Takfot och fasad, principdetaljer 1:10

STADSDEL	FASTIGHET	DIARENUMMER	
Gamla Stan	Gamla Stan 1:34	2020-11119	
BYGGNADSTYP	STATUS		SEKVN
Nybyggnad	BYGGLOVHANDLING		
ÄRENDET AVSER, ADDRESS	BETECKNING		SKALA
Flytande badhus och multifunktionsbyggnad	Takfot och fasad - principdetaljer		1:20

Munkbrohamnen 1			
ANSVARIG ARKITEKT			
Anssi Lassila		FIL	REV
Kontraktsperson		Takfot och fasad - principdetaljer.pdf	A
Aki Markkanen		OMRÅDE	NUMMER
RTAD AR	DATUM	PROJ. NR	
JP, TL	04.05.2021	ARK	1281
		NUMMER	A-42-6-001

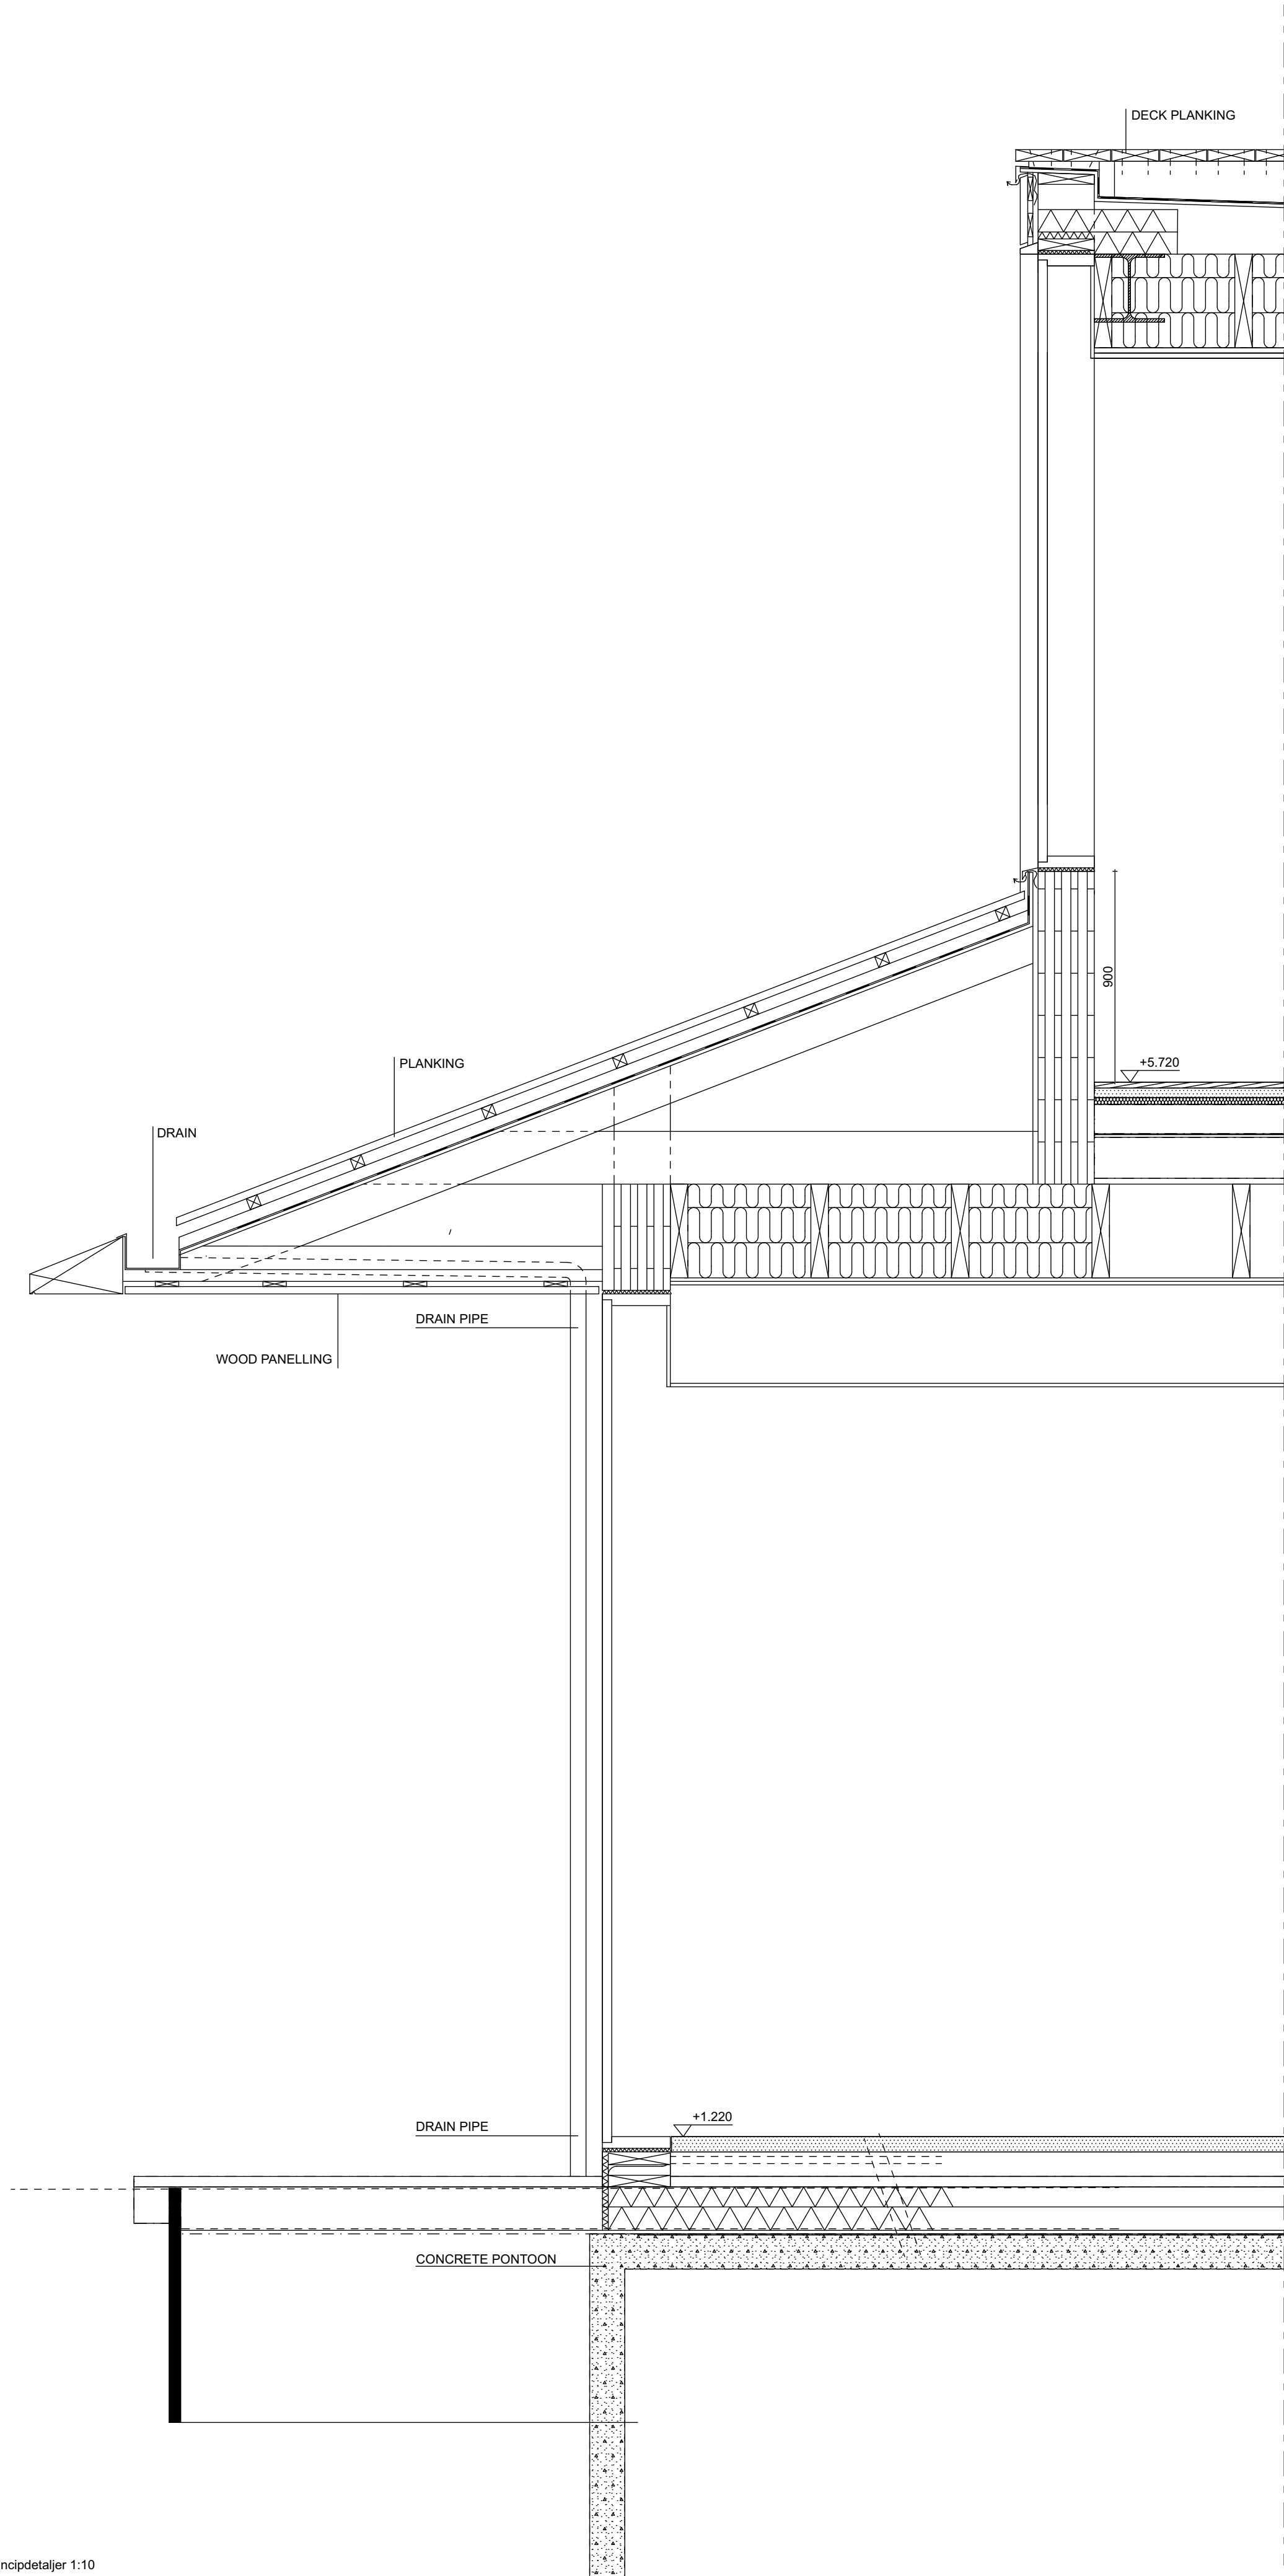
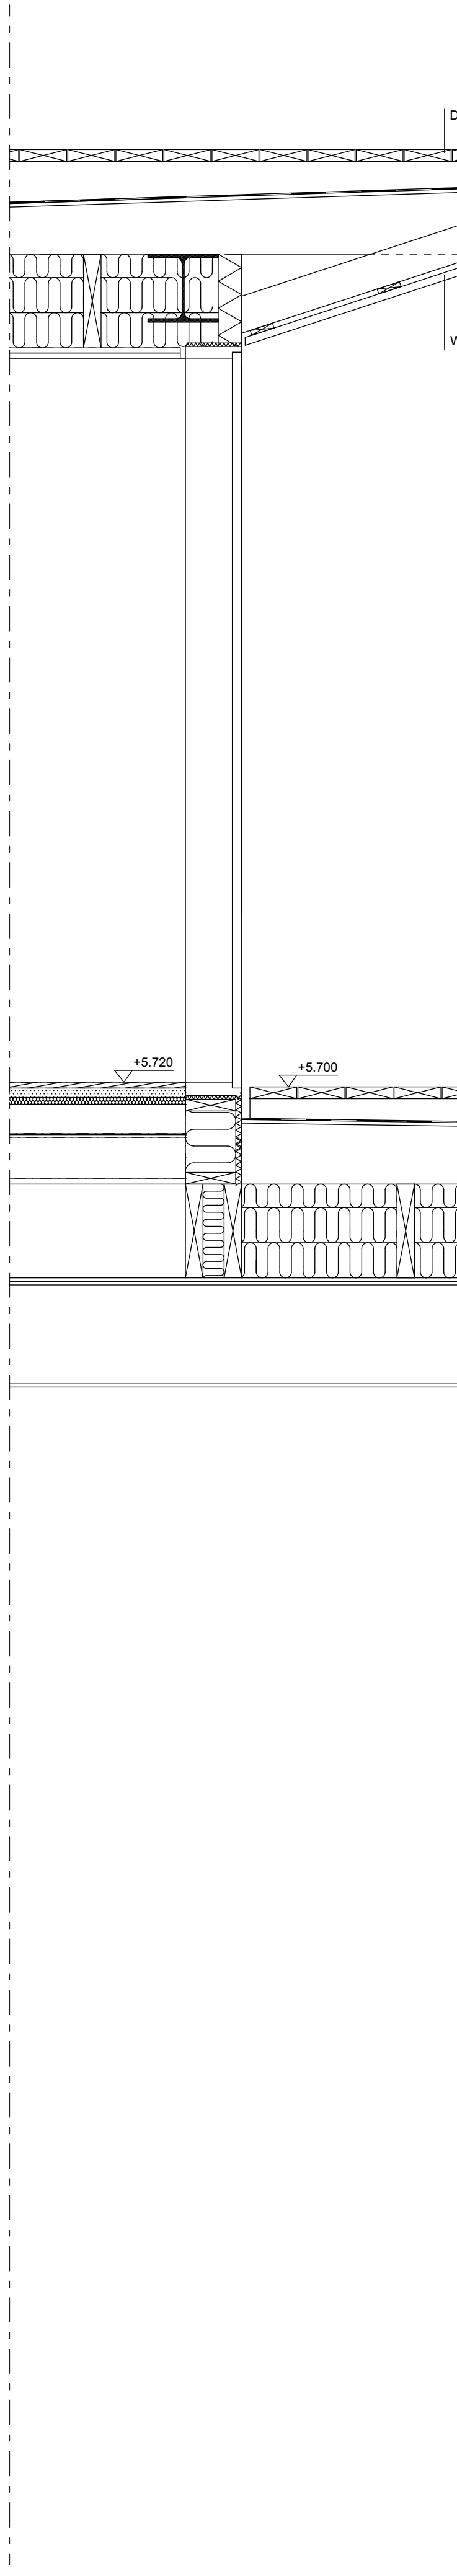
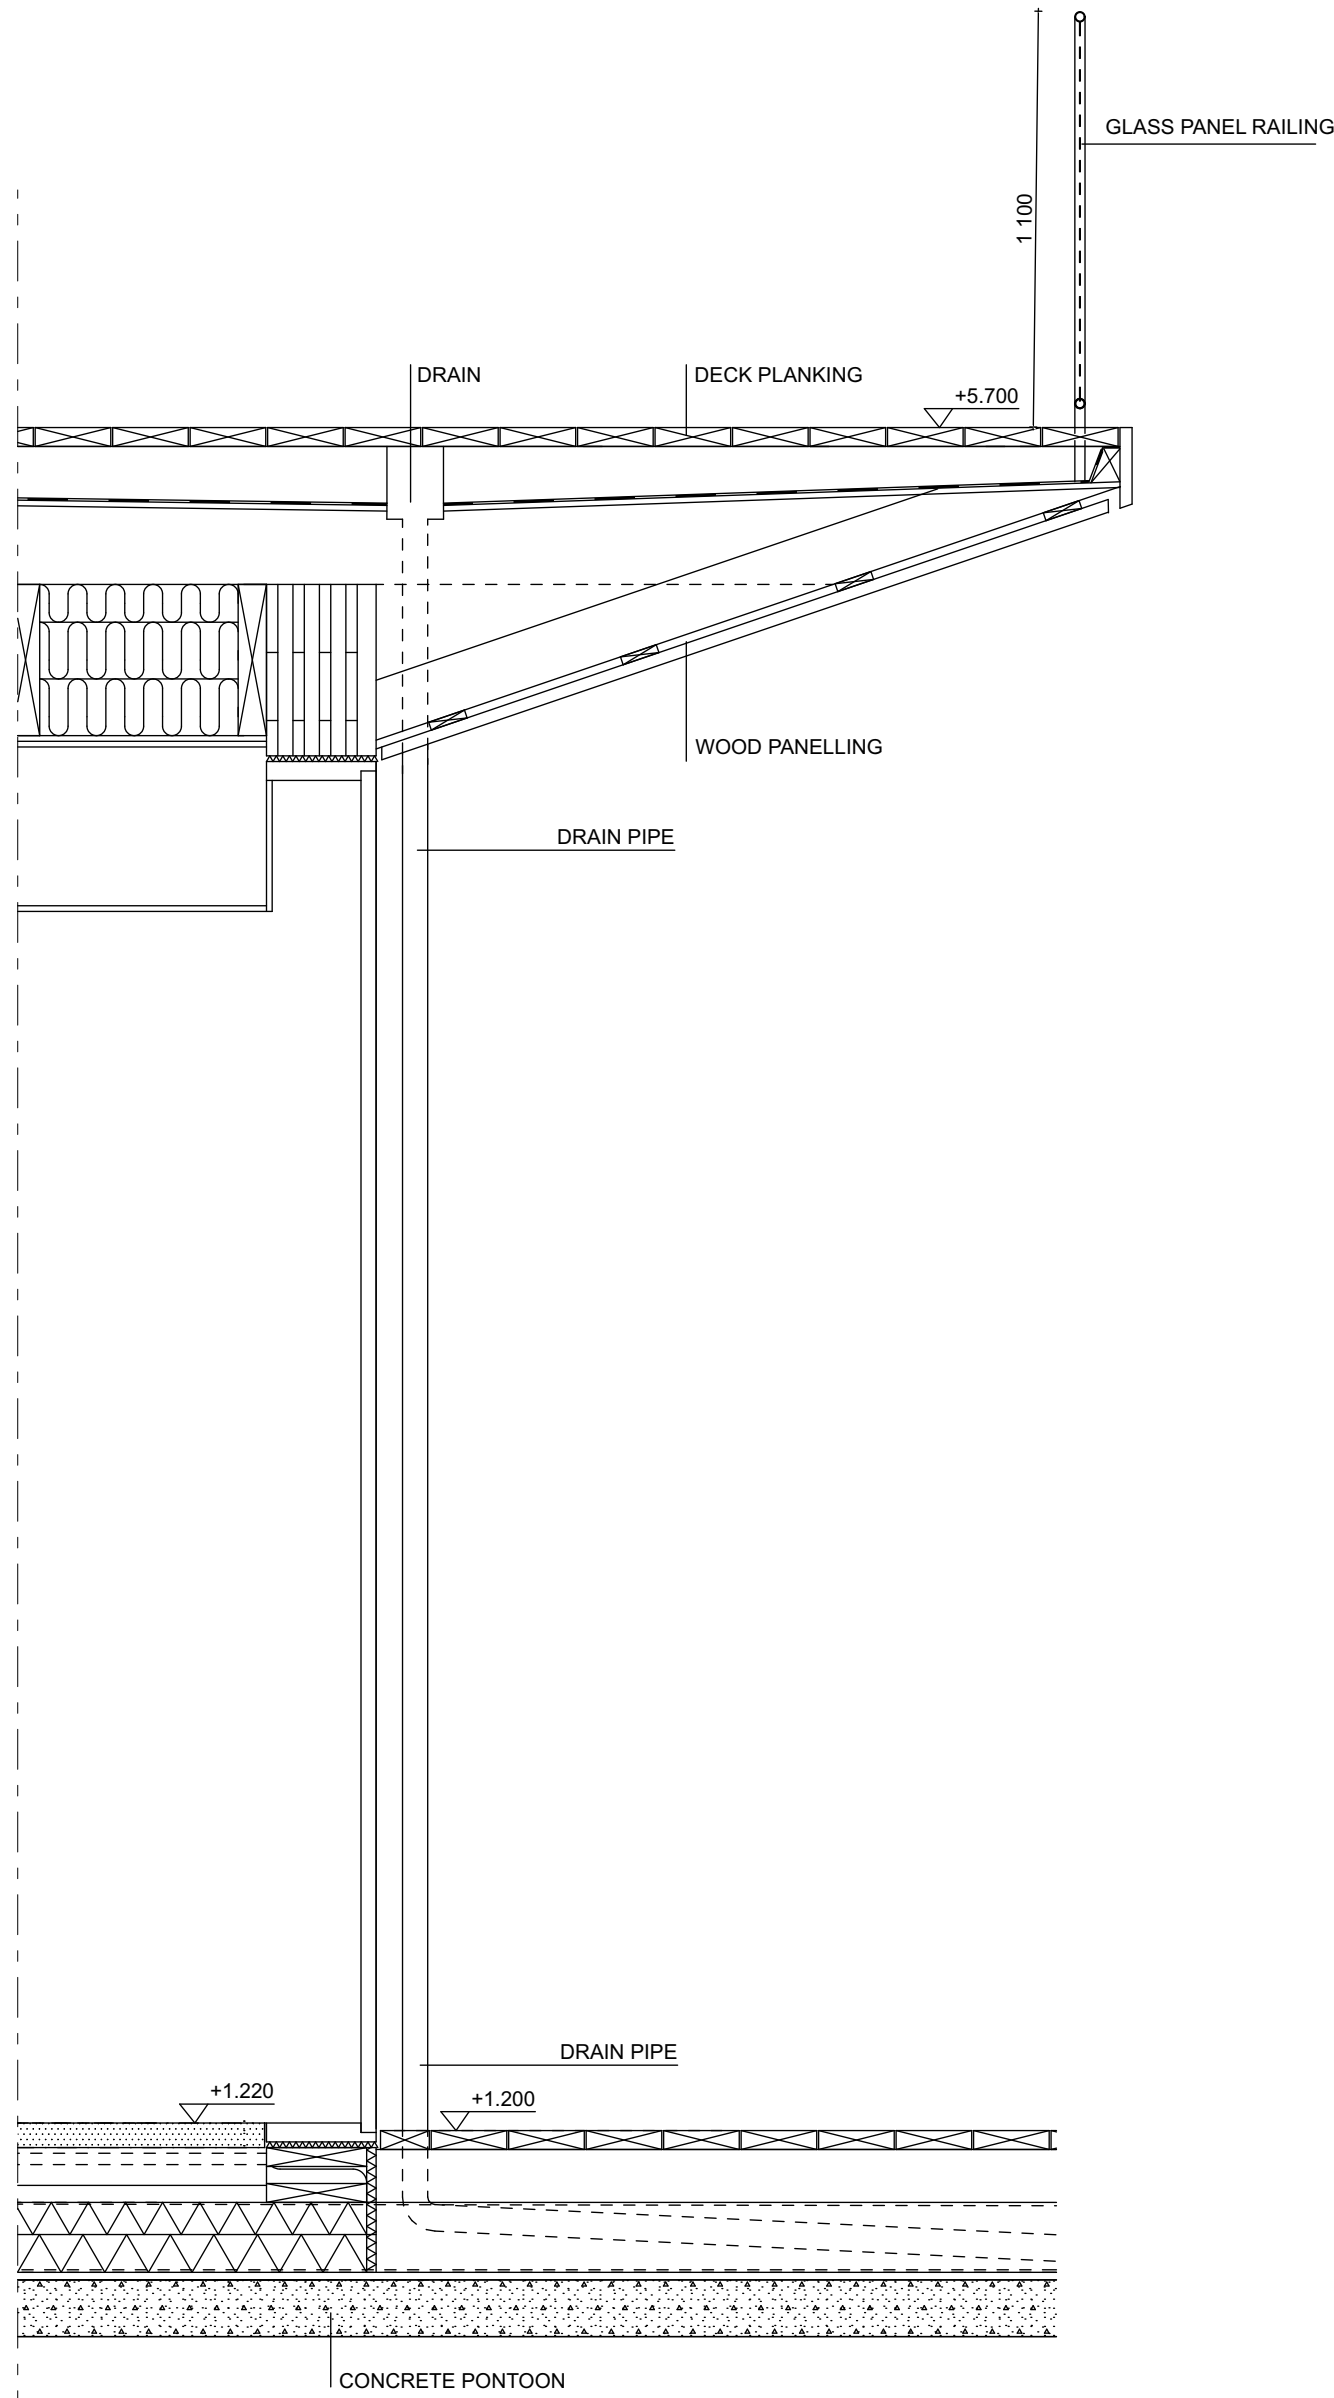
A	10.05.2021	The direction of the roof boarding of the box has been changed to vertical and the eaves detail of the box has been changed	AM
		The lower eave has been straightened	
		The eave detail above the rood window edge has been straightened vertical and the roofing blanks have been extended to meet edge
